RFP# 8525 Cosumnes River Blvd Rectifier Replacement Project Q&A's

COSUMNES RIVER BLVD
EXTENSION PROJECT
I-5 TO FRANKLIN BLVD
DRAINAGE AND UTILITY PLAN

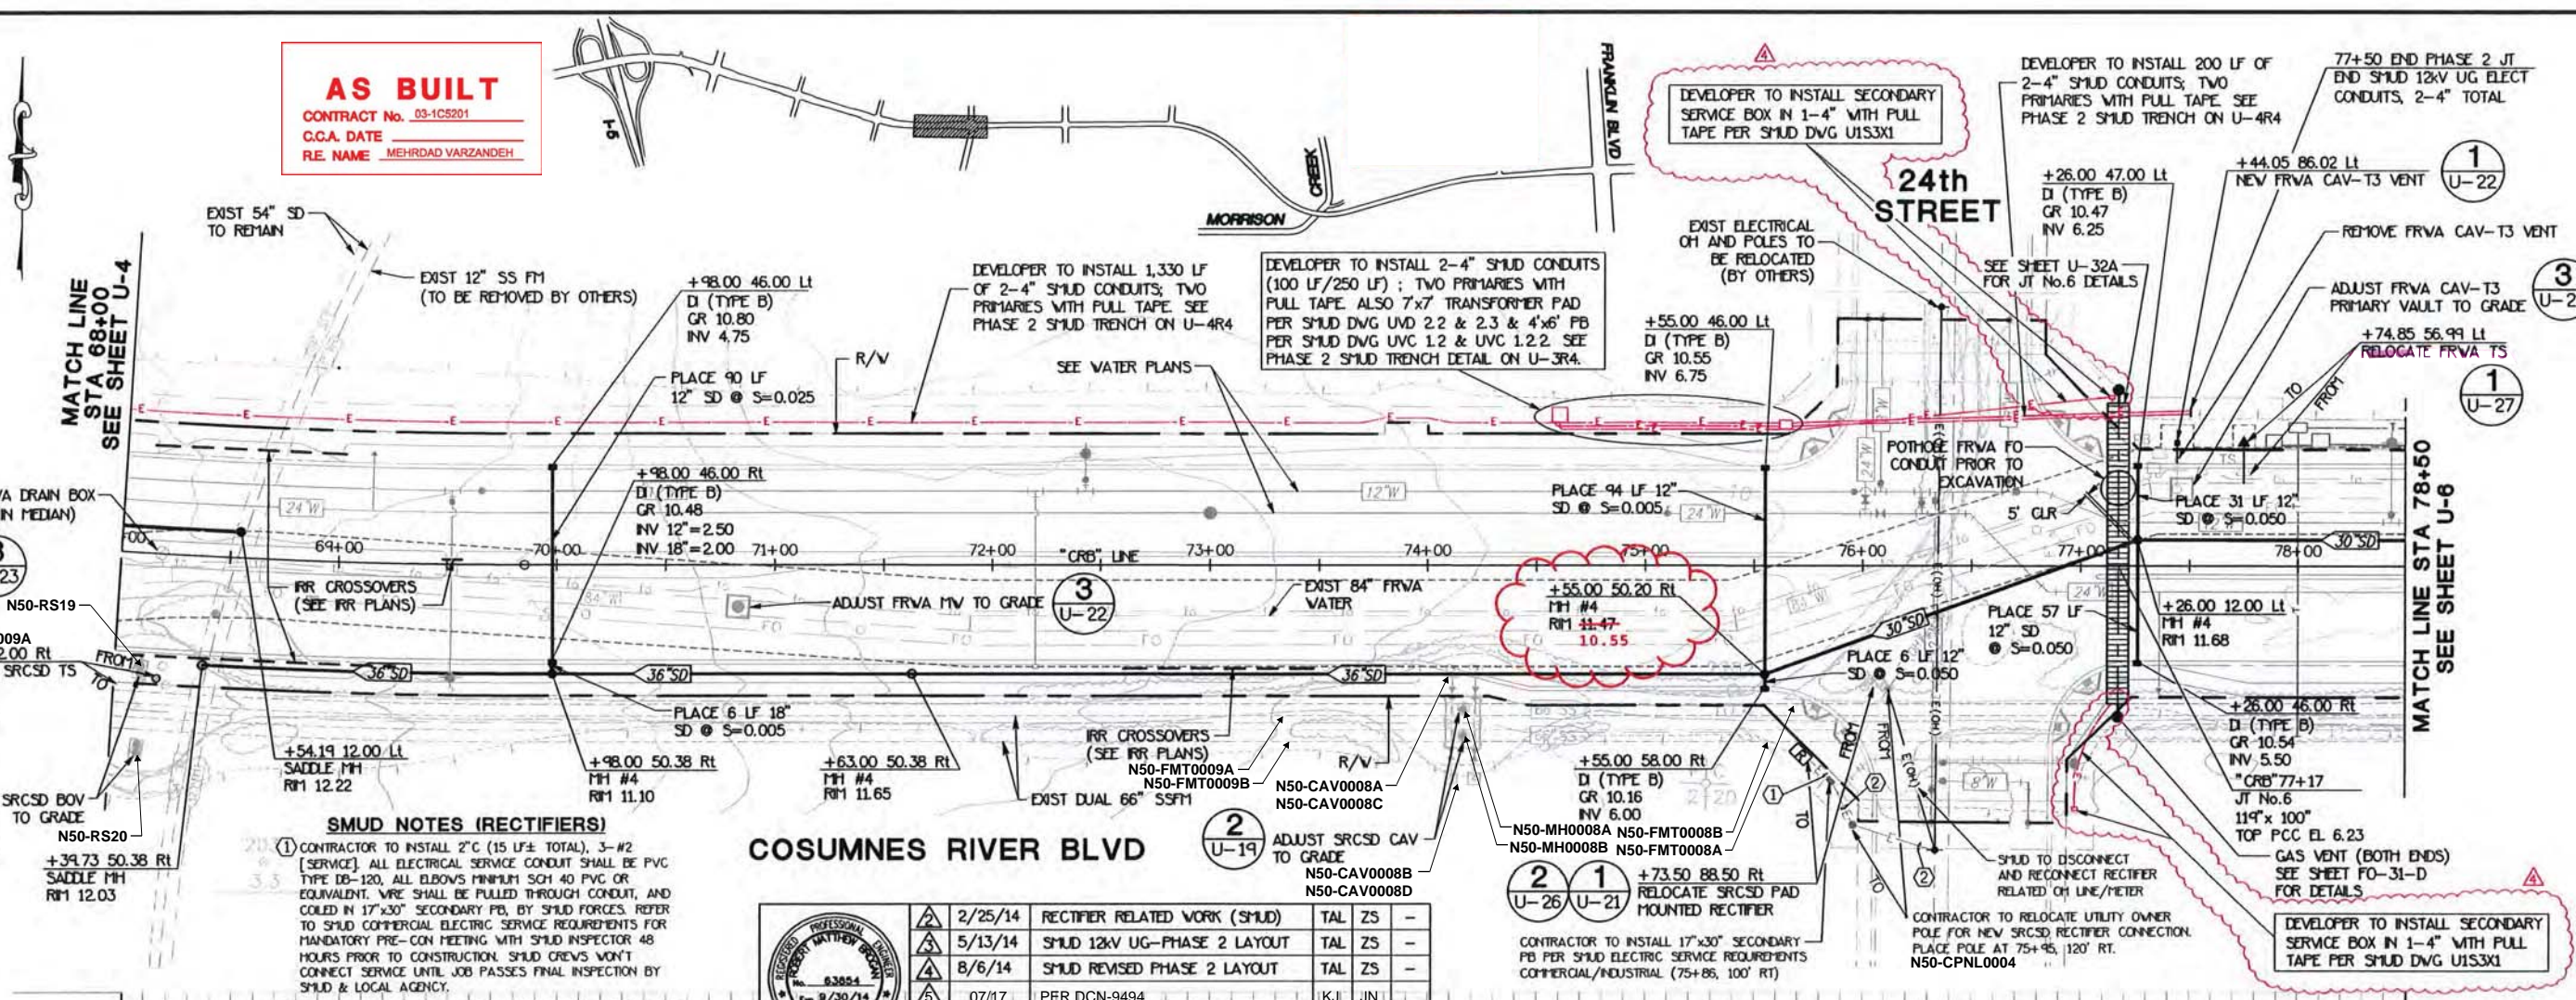
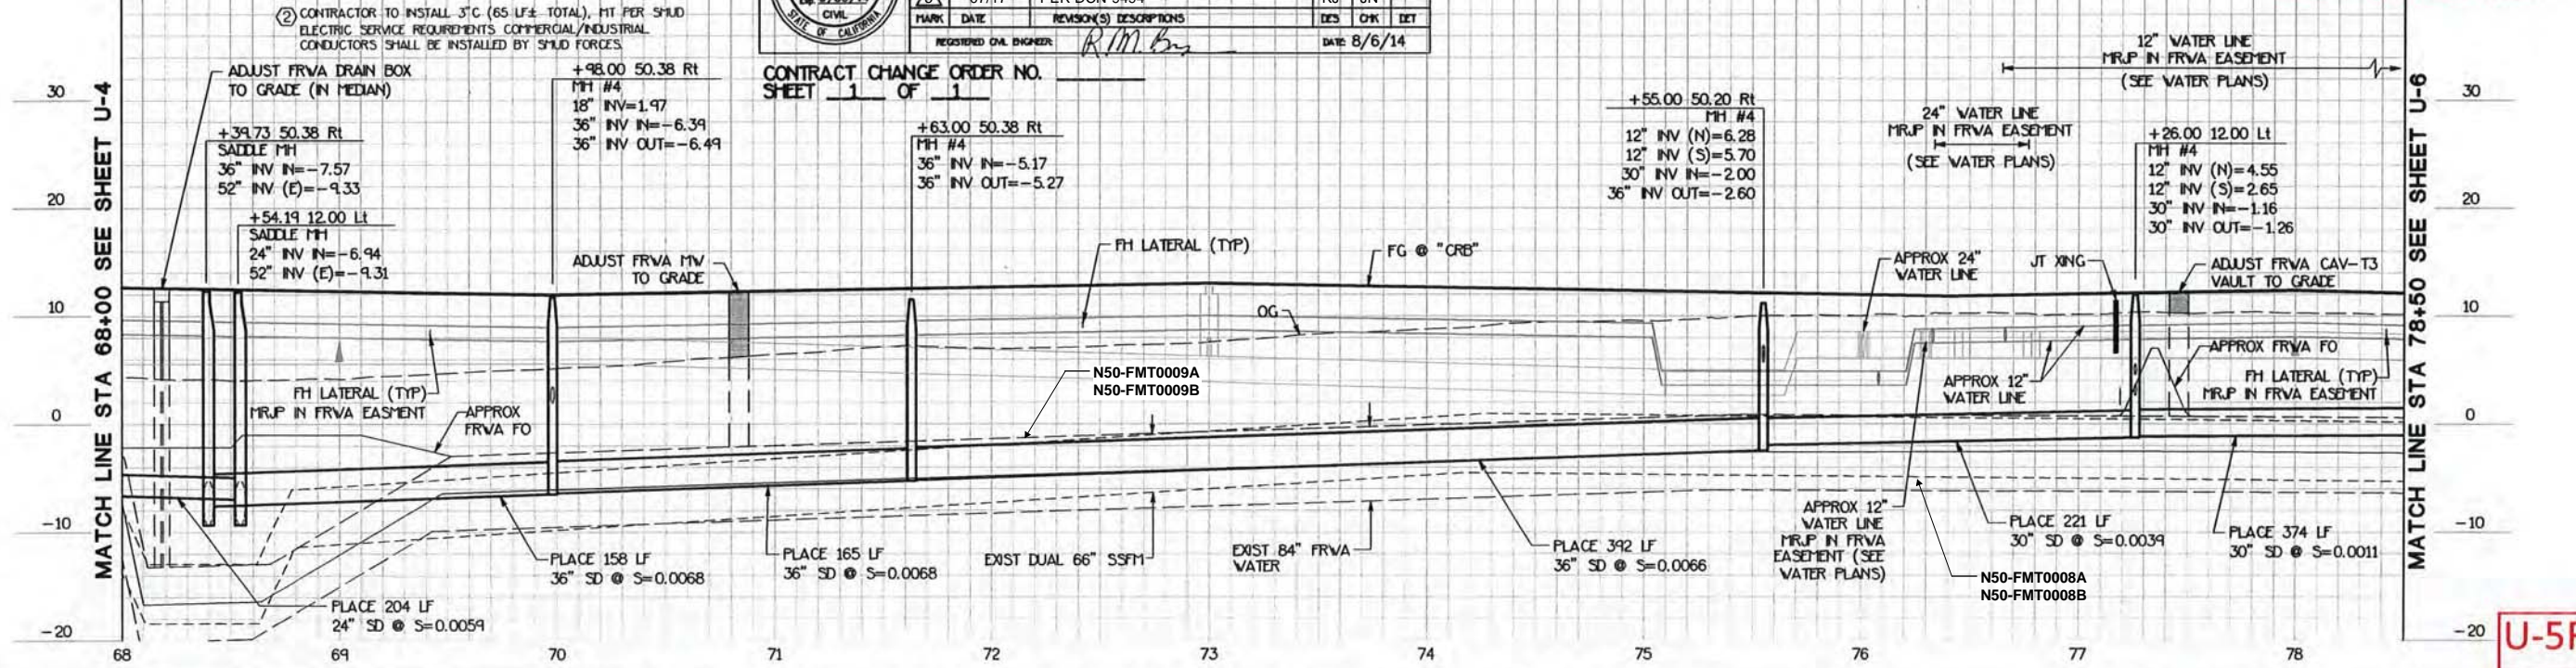
6. Is there any information available regarding right-of-way requirements or restrictions as they pertain to the rectifier location?

7. Are there any available as-built drawings related to the rectifier location, associated conduit, or structure/pipeline locations that can be provided?

The RFP does not include a dedicated right-of-way requirements section, because the replacement is in the same location as the existing rectifier, which was previously relocated outside the Cosumnes River Blvd right-of-way when the road

was constructed — as documented on the as-built drawings included in your proposal package.

Please see the attached as-built record drawing. Please note: This drawing is provided for informational reference only. It reflects conditions as of 2012.
